STAFF REPORT ACTION REQUIRED

Fence Exemption Request - 1 Bradbury Crescent (Amended)

Date:	January 9, 2008
To:	Etobicoke York Community Council
From:	Curtis Sealock, Manager, Municipal Licensing and Standards
Wards:	Ward 3 - Etobicoke Centre
Reference Number:	ML&S Folder No. 07-233798 FEN

Attachment 2: Site Plan

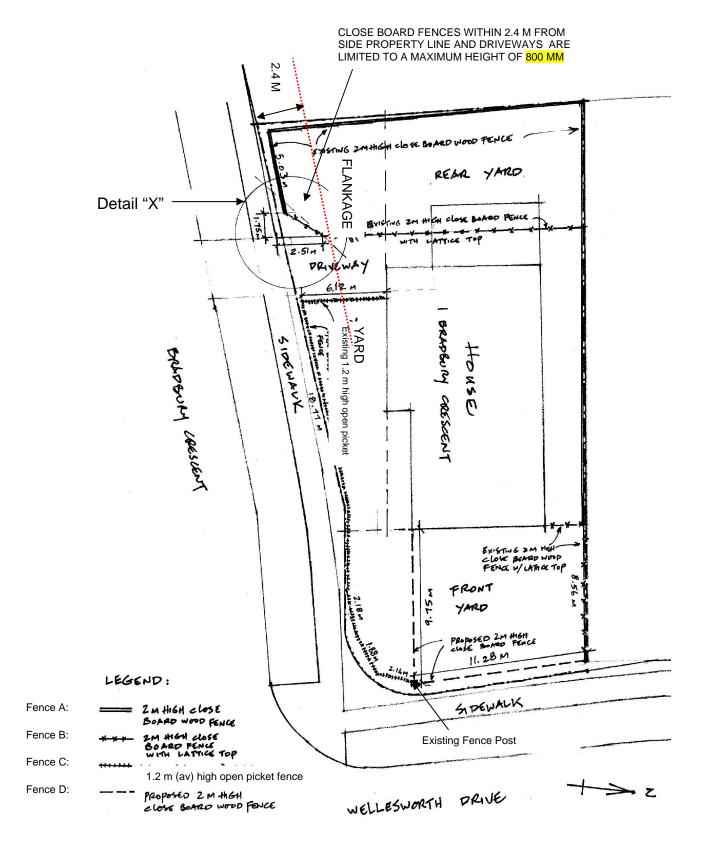
It should be noted that, notwithstanding the fence at the south west corner of the rear flankage yard beside the driveway entrance being constructed at an angle, it is only 1.75 metres away from the driveway (instead of the required minimum clearance of 2.4 metres). This fence is in violation of the Fence By-law [Attachments 2 and 6].

board wooden privacy fences at the front yard are in violation of the Fence By-law, although they are not expected to create any sight line obstructions to the traffic [Attachment 2].

Should the Etobicoke York Community Council decide to approve this Fence Exemption request, the 2 metres high close board wooden fence at the south west corner of the access to the driveway must be cut back for at least 650 millimetres and the rest of the fence realigned to provide a minimum sight line clearance of 2.4 metres from the driveway [Attachments 2 and 6].

Attachment 3: Photos showing the location of the existing and proposed fences

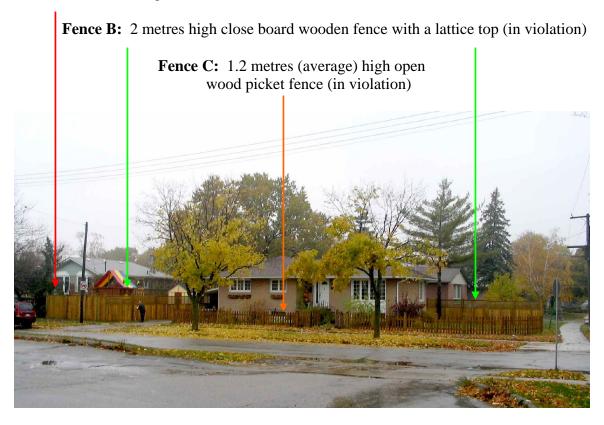
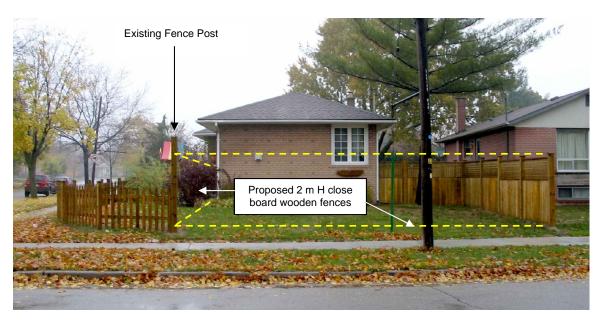
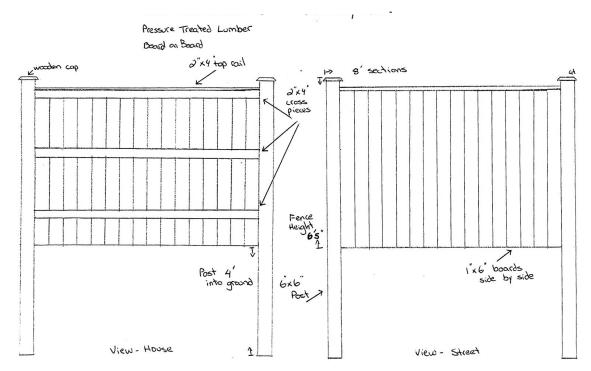
The open wooden picket fence (Fence C) extends into the front yard area, where it stops and connects to a 2 metres high fence post beside the sidewalk along Wellesworth Drive. On the north side of the front yard adjacent to the neighbouring property at 34 Wellesworth Drive, there is an existing 2 metres high close board wooden fence with lattice construction on top (Fence D) [Attachment 3].

To completely enclose the front yard for privacy, the owner/applicant proposed to erect a 2 metres high close board wooden fence on the south side to connect the south east corner of the house to the aforementioned fence post, and another similar fence alongside the sidewalk from this post to the existing fence on the north side [Attachments 2, 3 and 4].

Attachment 6: Photos showing the fence with traffic sight line problem

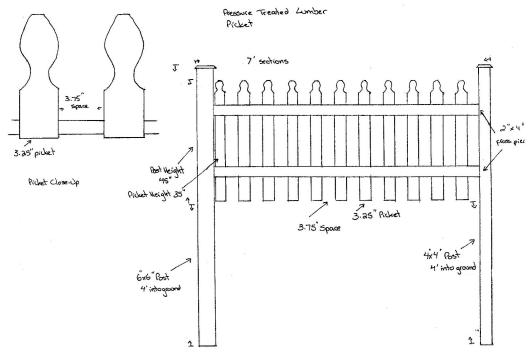
Existing 2 metres high close board wood fence with traffic sight line problem must be cut back to provide at least 2.4 metres clearance measured from the driveway (see Detail "X" in Attachment 2)
